Product Change Notification (PCN)

PCN #: 6B-2026

Ezurio is updating two components in the BOM for this SMARC family:-

5.1 Designator R41

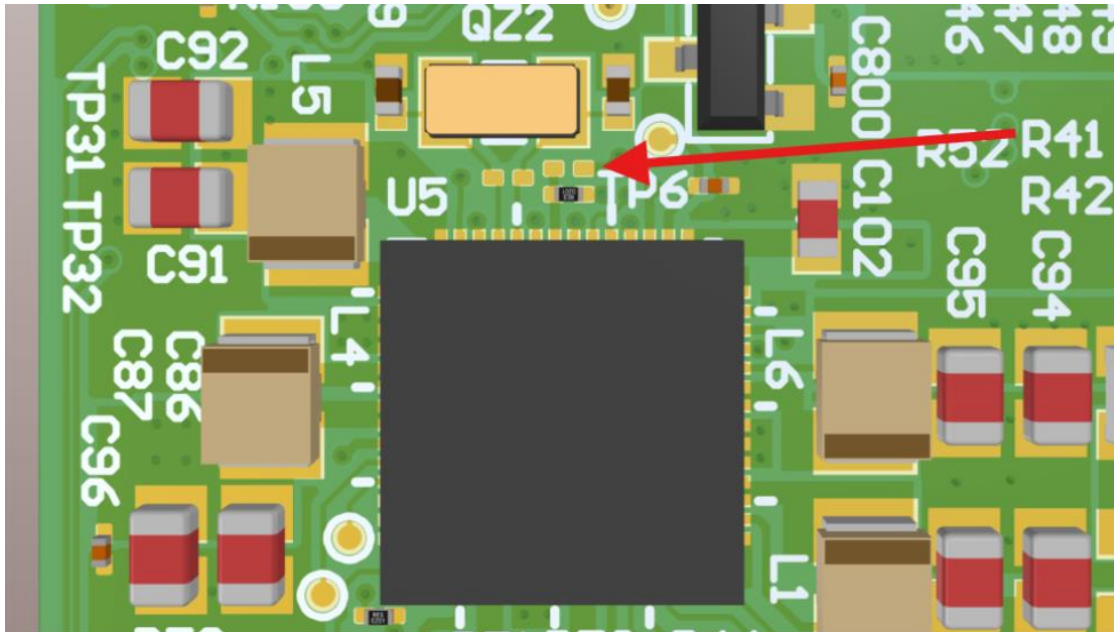
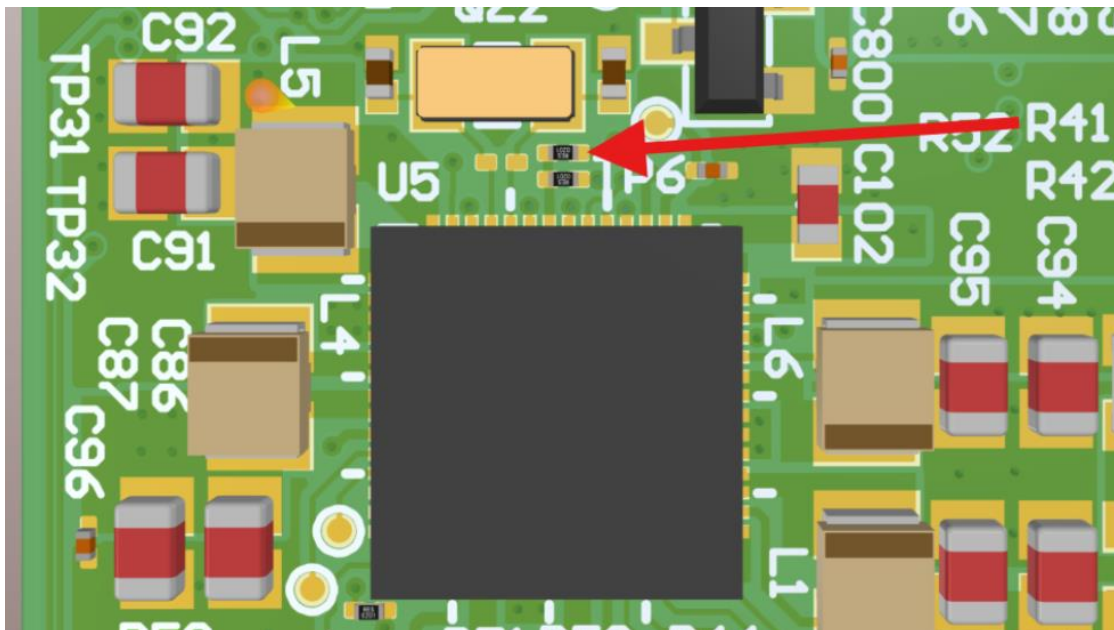
R41 will be populated with a 10 kΩ resistor.

- Old REV (R41 not populated)

- New REV (R41 populated)
